NPDES Stormwater Industrial and Construction Inspection Report

National Database Information	
Inspection Date: 03/04/2025	Entry/Exit Time: 9:00/15:00
NPDES ID Number: COR05I301	Inspection ID: 202503_COR05I301
Facility Type: Gas Processing Plant	Inspection Type: Stormwater Industrial
SIC Code: 1321 Natural Gas Liquids	
Lead Inspector/Affiliation/Telephone: Kevin Stockton/ERG/720-789-8050	
Inspector/Affiliation/Telephone: Shannon Egger/ERG/703-633-1600	
Inspector/Affiliation/Telephone: Geoff Hensgen/Southern Ute Indian Tribe/970-563-3111

Facility Location Information	
Site/Facility and Location: Ignacio Gas Plant 3746 Country Road 307 Durango, Colorado 81303 La Plata County	Mailing address: Harvest Four Corners, LLC 1755 Arroyo Dr, Bloomfield, New Mexico 87413
Latitude: 37.1442779 ° N	Longitude: -107.7864066 ° W
Receiving Water(s):	Unnamed tributary to Florida River
Impaired waters:	No

Photograph 10. Additional view, facing West, of dredged material outside of the fence line Drainage Area 15, as referenced in Photograph 9. Note piles are uncovered and uncontained.

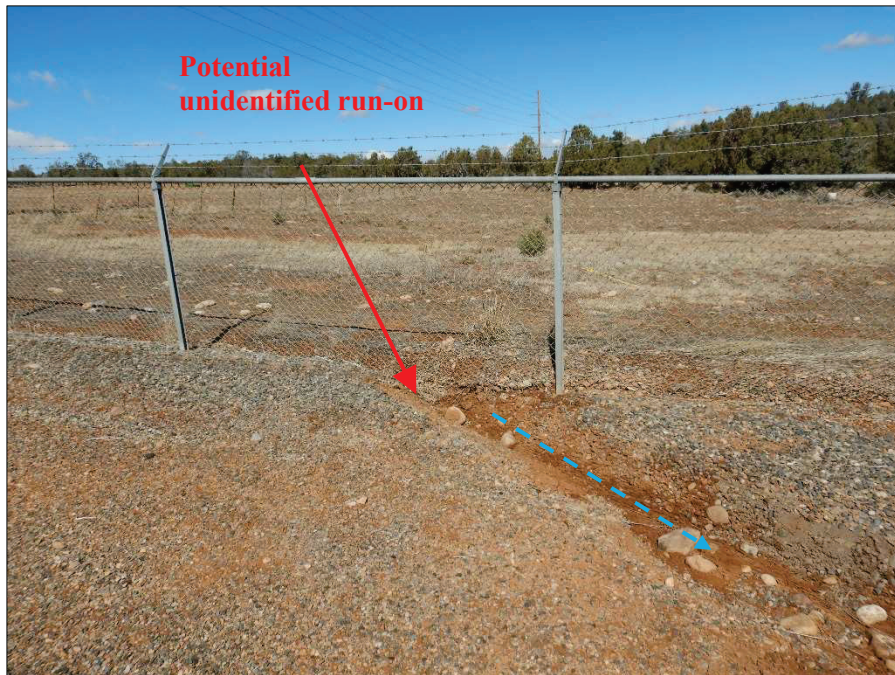
- a. Uncovered and uncontained piles of dredged sediment located outside of the fence line in the north area of the Facility (refer to Appendix A, Photographs 9 and 10).

In accordance with Part 2.1 of the Permit, select, design, install, and implement stormwater control measures to minimize pollutant discharges in stormwater runoff from dredged sediment and scrap and reclaimed metal materials. Provide the EPA with a written narrative description and photographs of the corrective actions to address this finding.

Photograph 11. View, facing North, of potential unidentified run-on in Drainage Area 15.

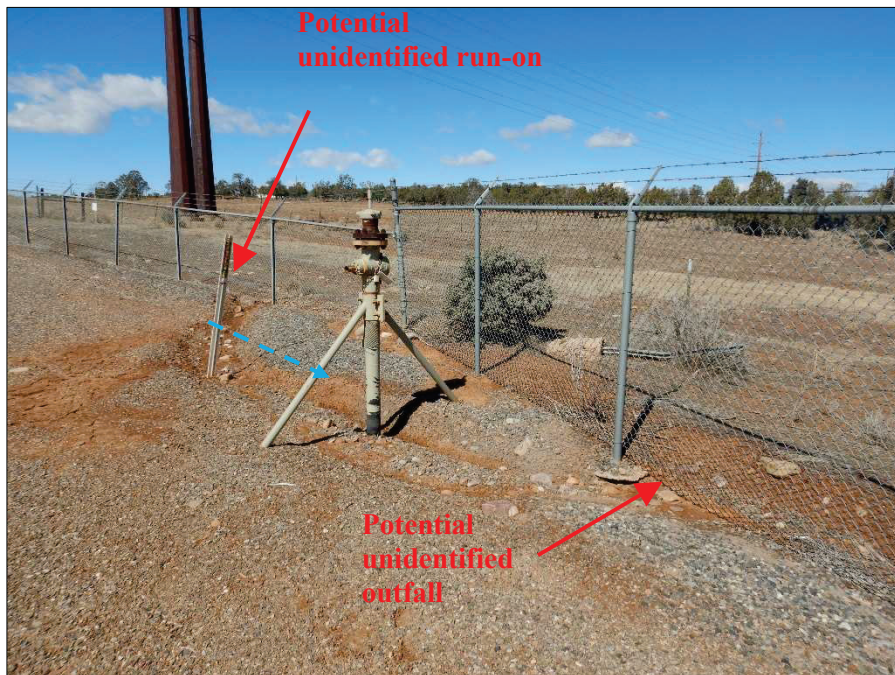
- c. Stormwater monitoring points (refer to Appendix B, Exhibit 1).
- d. Locations of stormwater run-on to the Facility from neighboring properties (refer to Appendix B, Exhibit 1). The Inspection Team observed one location along the Facility's northeast perimeter (Drainage Area 15) where stormwater appeared to flow onto the Facility from the neighboring undeveloped property (refer to Appendix A, Photographs 11 and 12).

In accordance with Part 6.2.2 of the Permit, update the site map to include the locations of all stormwater conveyances including ditches, pipes, and swales, all stormwater pollutant sources, stormwater monitoring points, and all stormwater inlets and discharge points, with a unique identification code for each discharge point and an approximate outline of the areas draining to each discharge point. Include the updated site map in the SWPPP and submit the updated SWPPP and site map to EPA.

Photograph 12. View, facing Northwest, of potential unidentified run-on and outfall in Drainage Area 15, as referenced in Photograph 11.

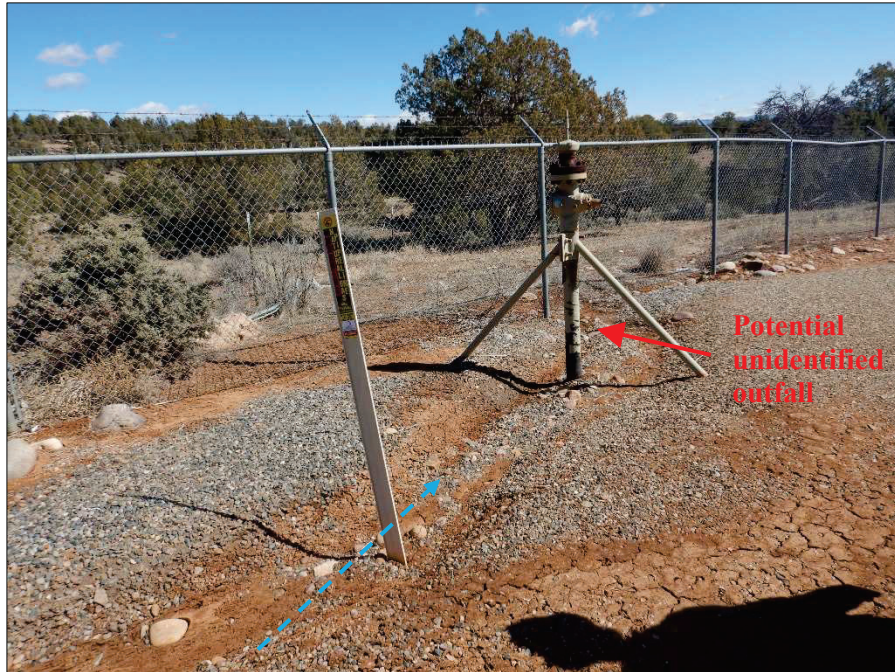
- Drainage Area 15 contains three outfalls on the site map; however the Inspection Team observed an additional three potential outfalls (refer to Appendix A, Photographs 12 through 14, 17, 18 and 25).

Photograph 19. View, facing South, of a potential unidentified outfall point in Drainage Area 11.

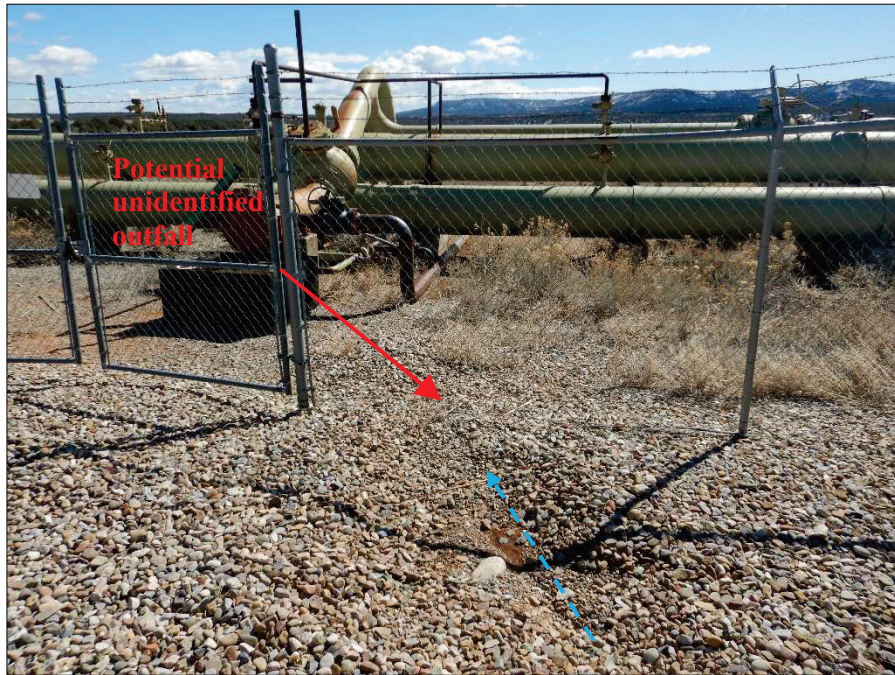
- Drainage Area 11 contains one outfall on the site map; however, the Inspection Team identified an additional potential outfall (refer to Appendix A, Photographs 19 and 20).

Photograph 38. View, facing West, of the bank of the ditch that drains into Gosney Pond. Note the rilling on the bank.

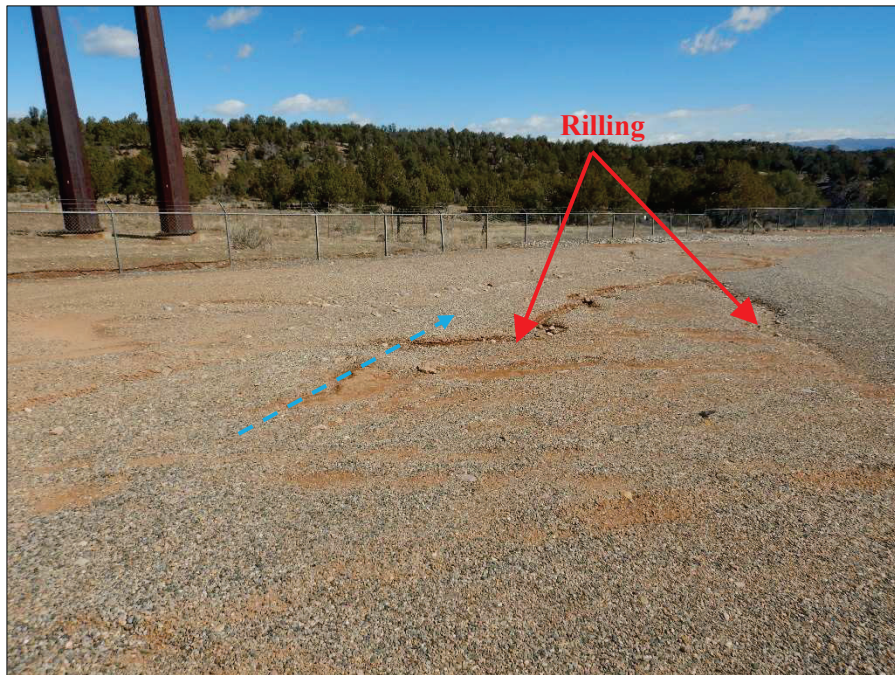
- a. The bank of the ditch that drains into Gosney Pond (refer to Appendix A, Photograph 38).
- b. The stormwater drainage pathway along the fence line in northeastern corner of Drainage Area 5 (refer to Appendix A, Photograph 39).

In accordance with Part 2.1.2.5 of the Permit, stabilize exposed soils and use flow velocity dissipation devices at discharge locations to minimize channel and streambank erosion and scour in the immediate vicinity of discharge points. Use structural and non-structural control measures to control the discharge of sediment. Provide the EPA with a written narrative description and photographs of the corrective actions to address this finding.

Photograph 43. View, facing North, of bank of the ditch leading to Outfall IGP-011. Note rilling on the unstabilized bank.

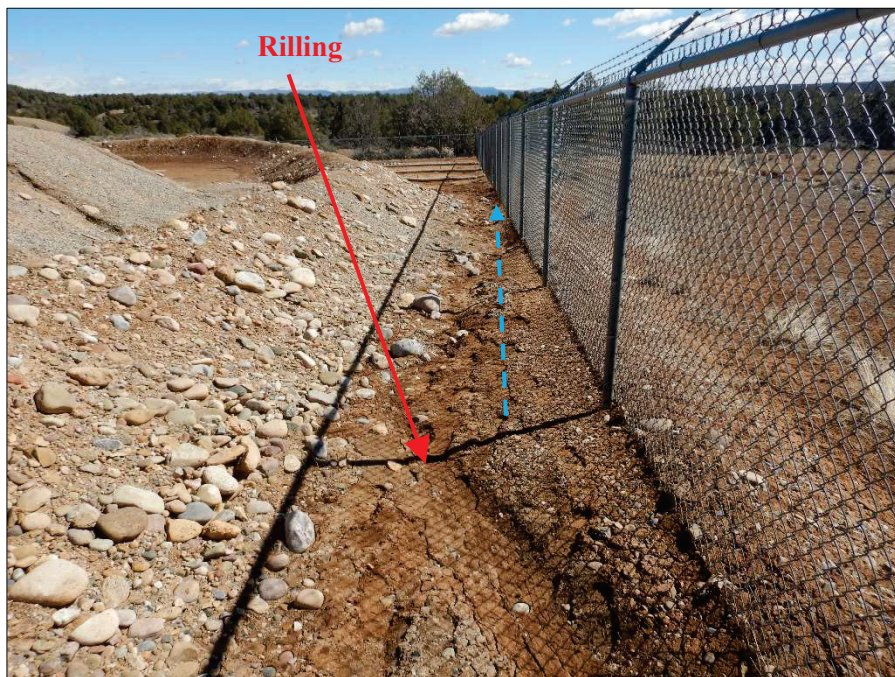
- c. The western bank of the decommissioned West Excess Pond (refer to Appendix A, Photographs 40, 41, and 42).
- d. The western bank of the ditch leading to Outfall IGP-011 from the culvert at the western end of the North Evaporation Stormwater Holding Pond (refer to Appendix A, Photograph 43).

Photograph 45. View, facing South, of outlet of culvert leading to West Excess Pond. Note evidence of erosion.

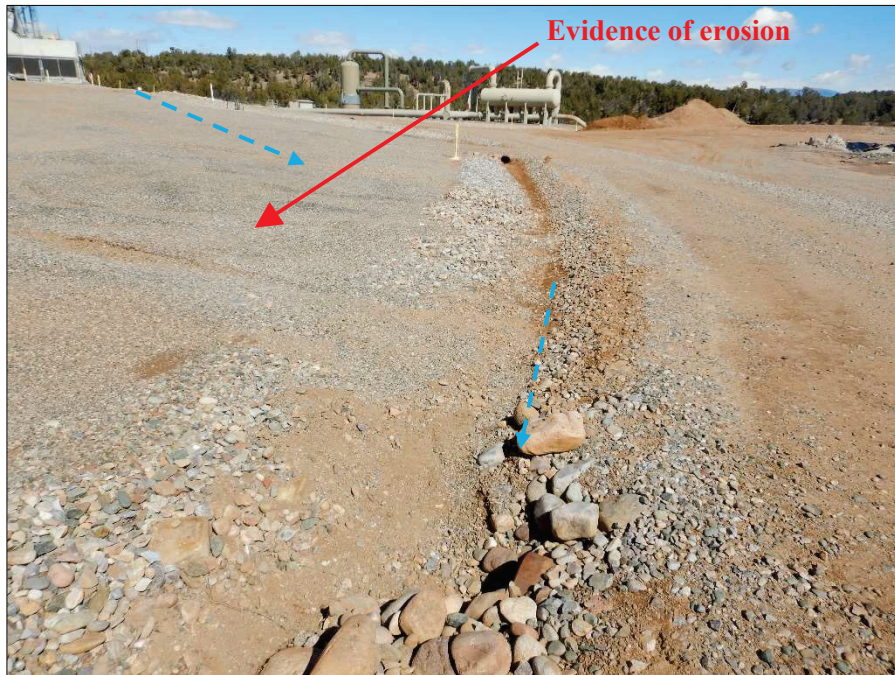
- e. Along the fence line in Drainage Area 15, south of the Soil Drying Containment area (refer to Appendix A, Photograph 44).
- f. The stormwater drainage pathway leading to West Excess Pond (refer to Appendix A, Photograph 45).

Photograph 46. View, facing Northeast, of a stormwater drainage path in Drainage Area 15 which leads to Outfall IGP-006. Note the evidence of erosion on the upgradient slope.

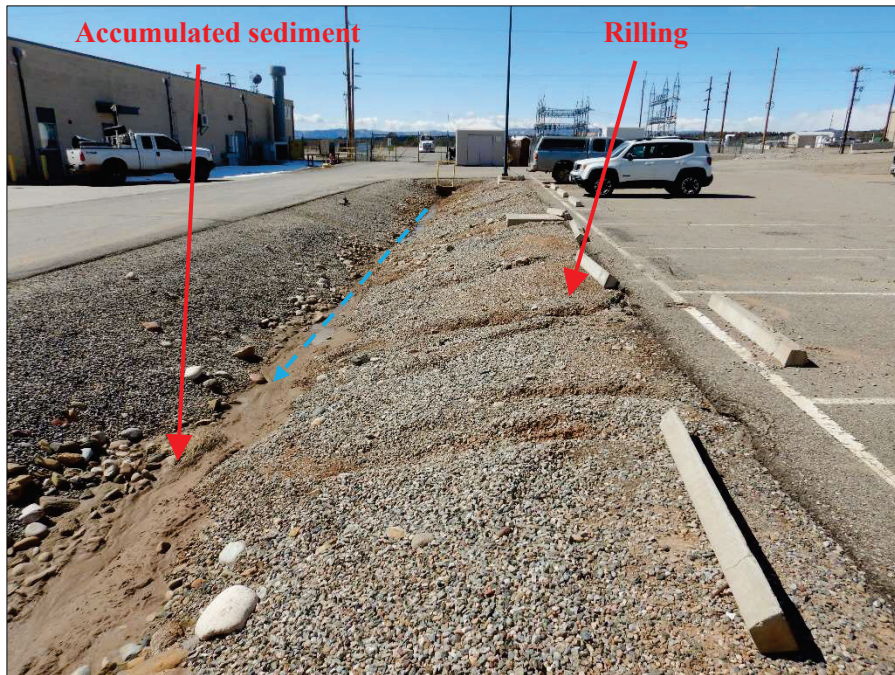
- g. A slope upgradient from a stormwater drainage path in Drainage Area 15 which leads to Outfall IGP-006 (refer to Appendix A, Photograph 46).
- h. The bank of the ditch near the parking lot in the west area of the Facility, which drains to North Evaporation Stormwater Holding Pond (refer to Appendix A, Photograph 47).

Photograph 71. View, facing West, of inlet of culvert in Drainage Area 1 leading to Outfall IGP-001.

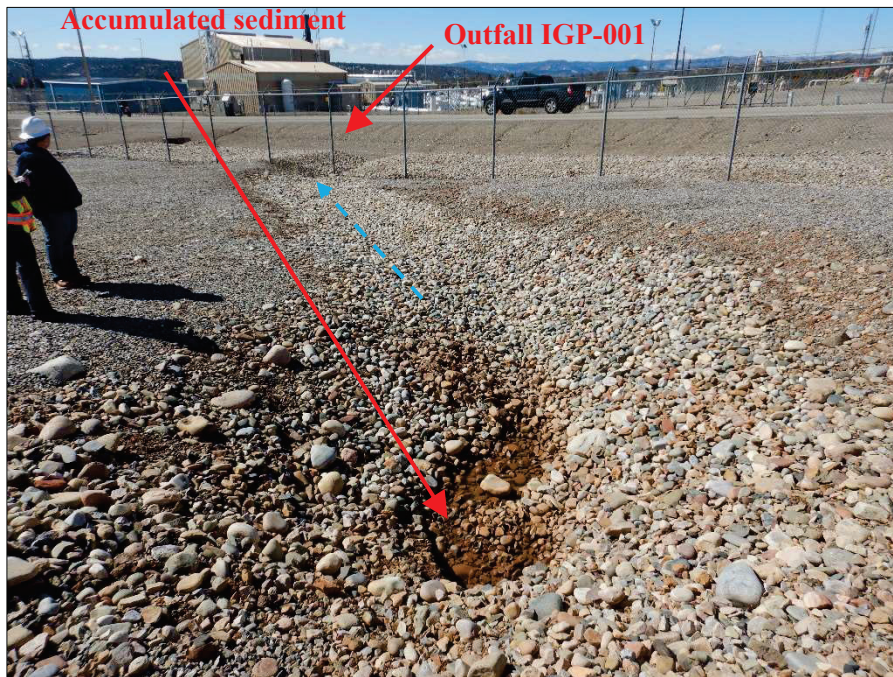
- l. The ditch upgradient from Outfall IGP-001 (refer to Appendix A, Photographs 70, 71, and 72).
- m. A drainage ditch in the northwestern corner of Drainage Area 15, which drains to Outfall IGP-003 (refer to Appendix A, Photographs 73 and 74).

Photograph 97. View, facing Southwest, of Outfall IGP-009. Note accumulated sediment.

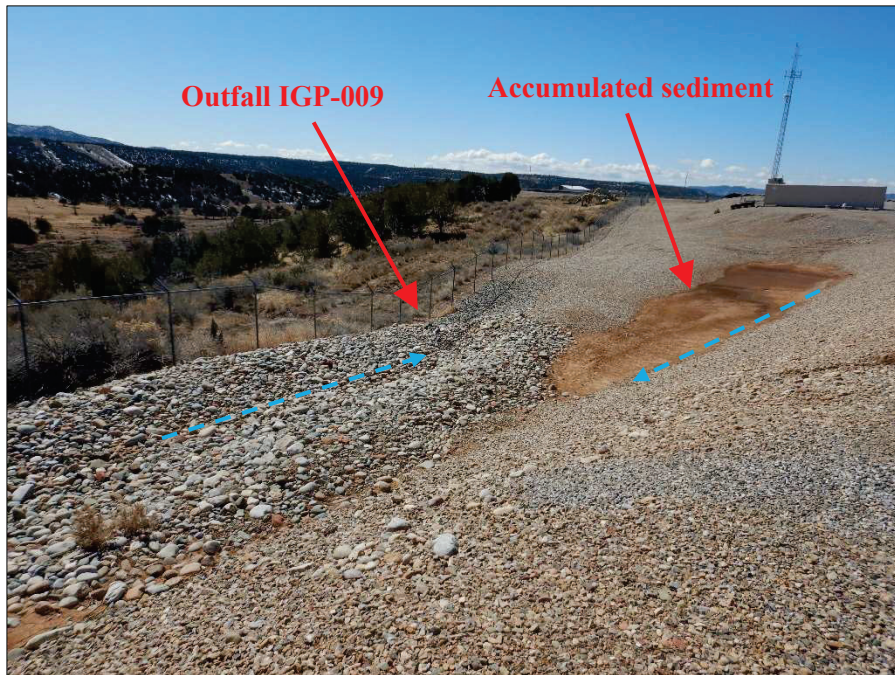
- r. A drainage ditch conveying stormwater from the northern corner of Drainage Area 6 to Outfall IGP-006 (refer to Appendix A, Photographs 91 through 94).
- s. A culvert and stormwater drainage pathways upgradient from Outfall IGP-009, south of the East and West Excess Ponds (refer to Appendix A, Photographs 95 through 99).
- t. In a ditch along the west berm of Clearwater Pond in the south-central area of the Facility (refer to Appendix A, Photograph 100).
- u. Upgradient from a culvert that drains into the boneyard in Drainage Area 6 (refer to Appendix A, Photograph 101).
- v. Inside the Outfall IGP-011 discharge pipe and in the stormwater drainage pathway upgradient from Outfall IGP-011 (refer to Appendix A, Photographs 102, 103, and 104).
